July 31, 2016

Re: First Request for Additional Information (RAI)
Pasco County – Solid Waste
Facility Name: Enterprise Road Class III Recycling and Disposal
Facility Site ID: 87895
DEP Application Nos.: 177982-023-SC/T3 and 177982-024-SO/T3

PROJECT NO.:	02000-144-14
SCALE:	AS SHOWN
DATE:	MARCH 2016
DRAWING:	C3.00

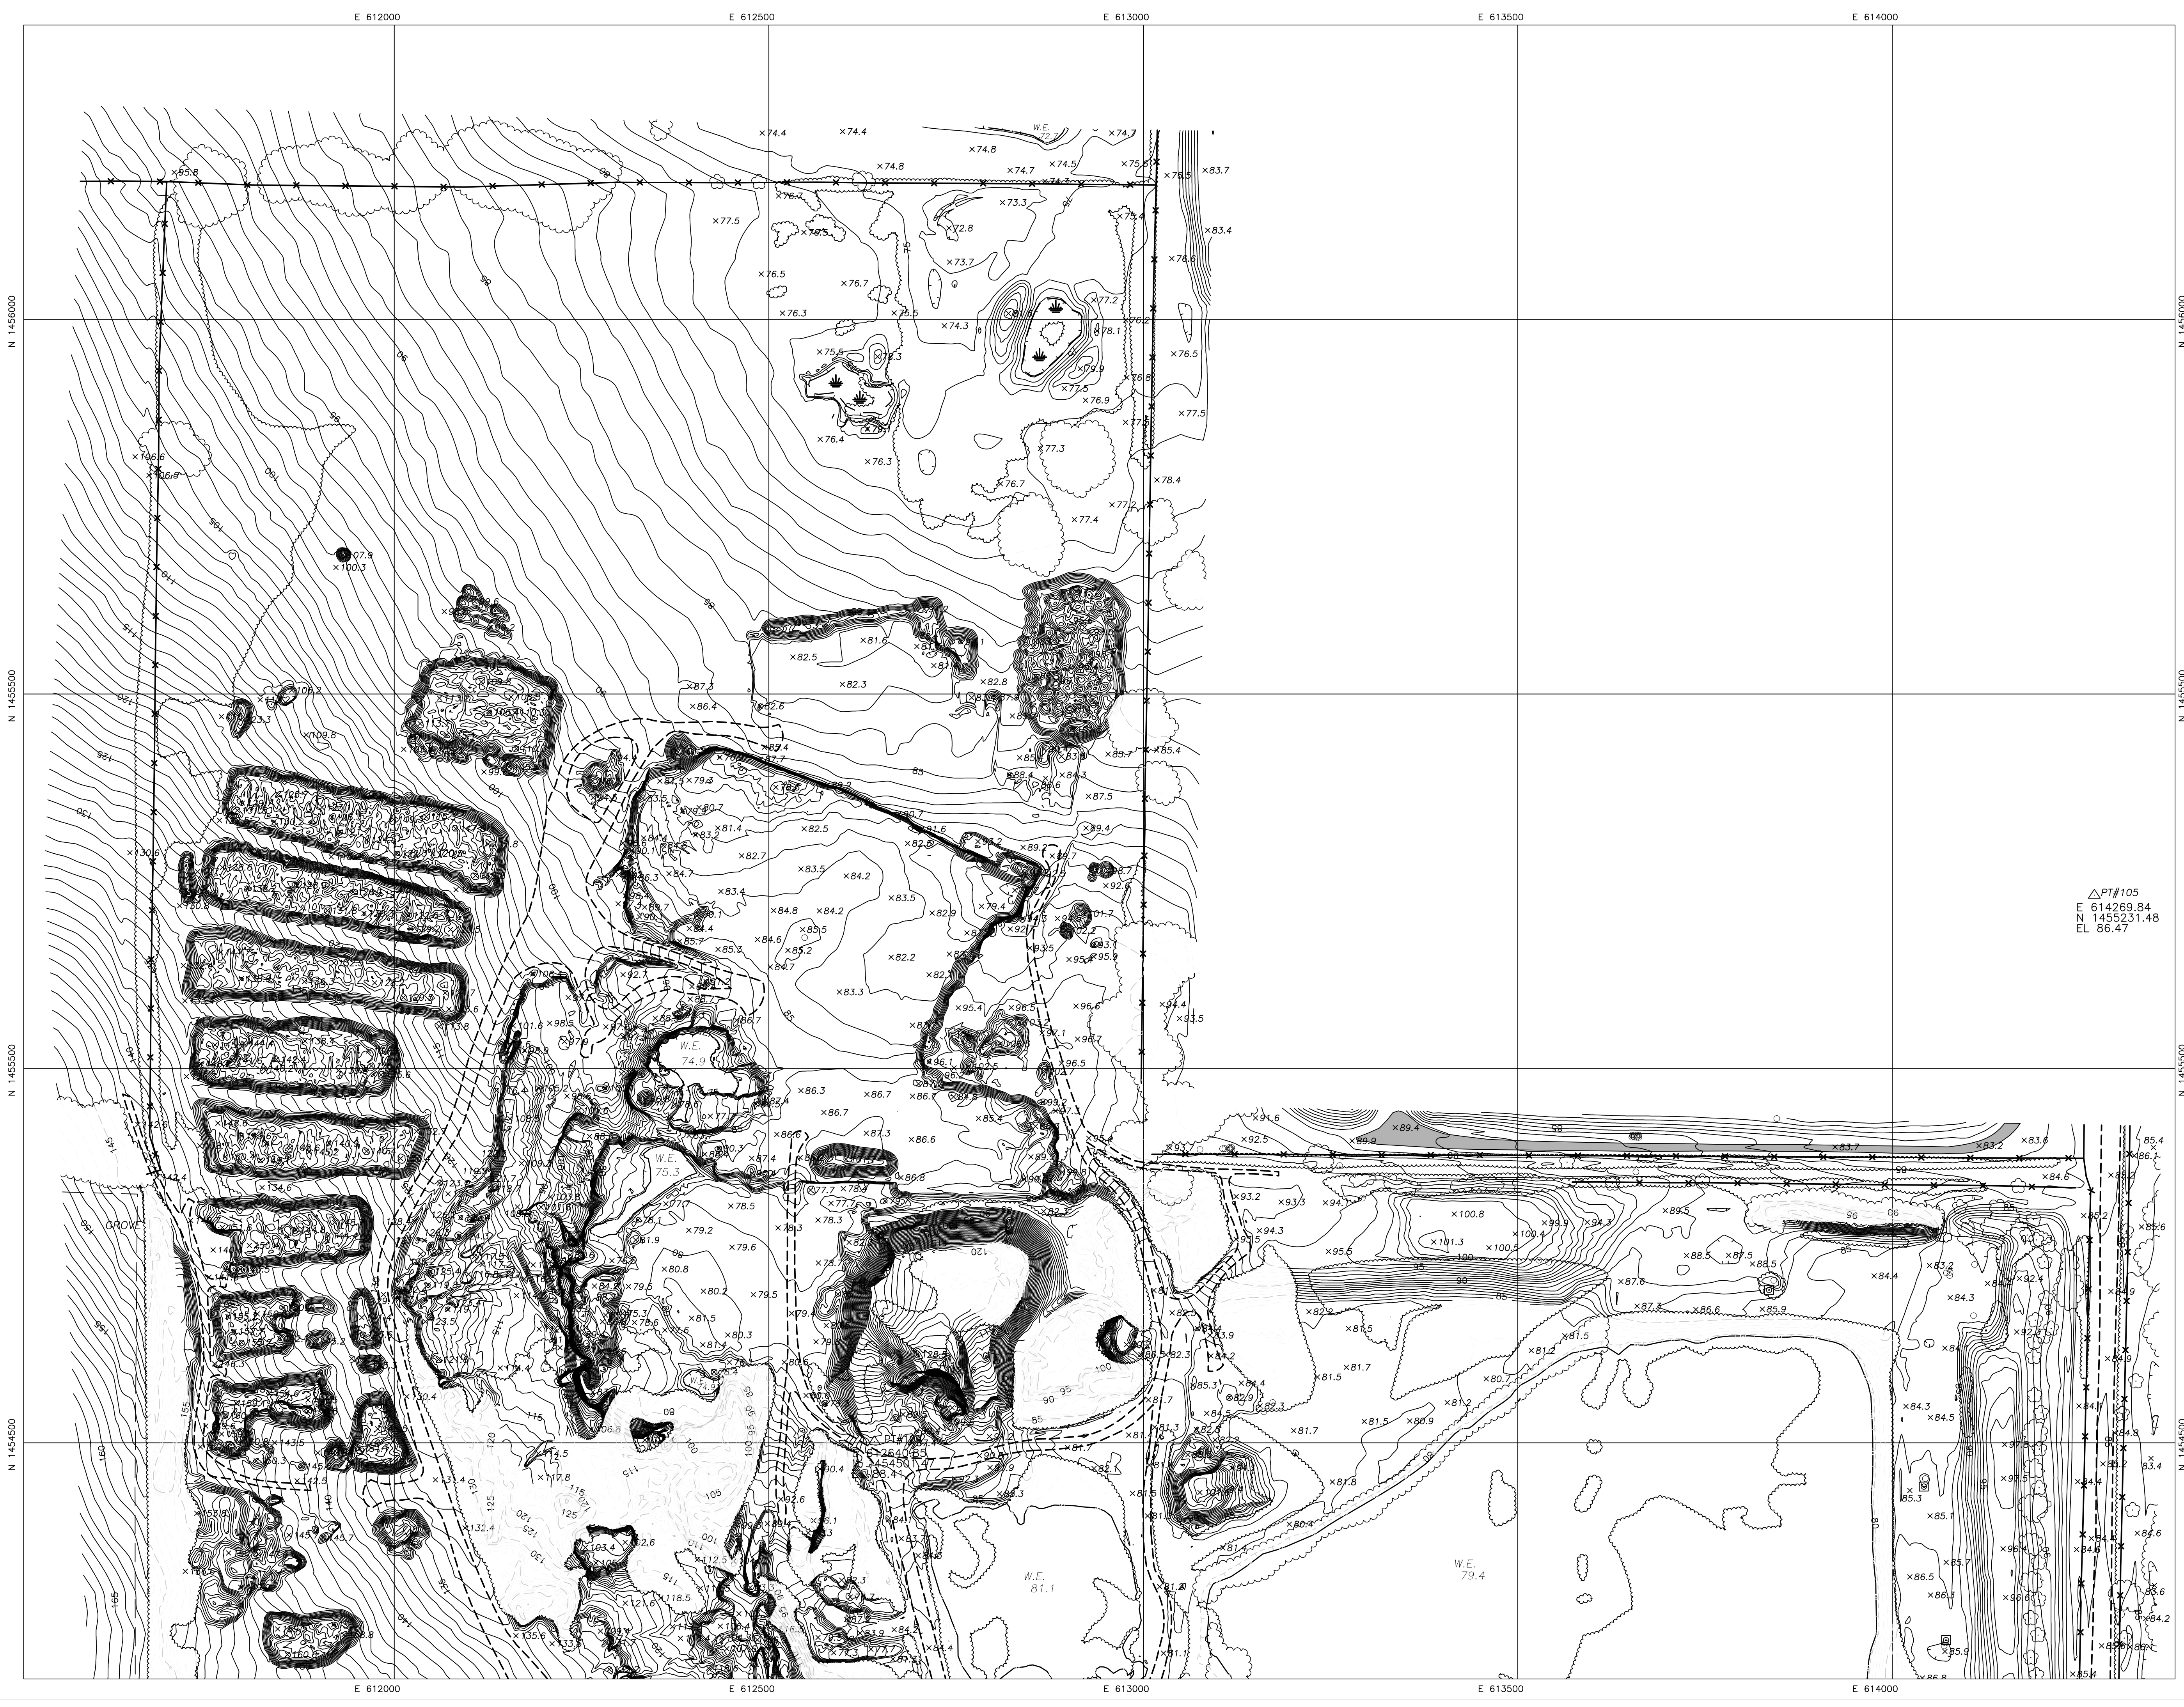
Comment 27.a: Detail 1: This detail appears inconsistent with Drawings C2.00 and C2.10. Please verify and revise as appropriate.

Comment 27.b: Detail 2: It is unclear where the temporary diversion swale will be constructed for Cell 16 and where the stormwater will be diverted to. Please explain and revise this drawing and/or Drawings C1.00 and C1.10, as appropriate.

Comment 27.c: Details 5 and 6: There are not north and east clay side slopes proposed for the construction of the Cell 16 bottom liner. Please verify the purpose of these details and/or remove these details, as appropriate.

RESPONSE 27.a: Drawing C3.00 Detail 1 has been revised to be consistent with drawings C2.00 and C2.10.

RESPONSE 27.c: Drawing C3.00 Details 5 and 6 have been modified to refer only to Cell 7.
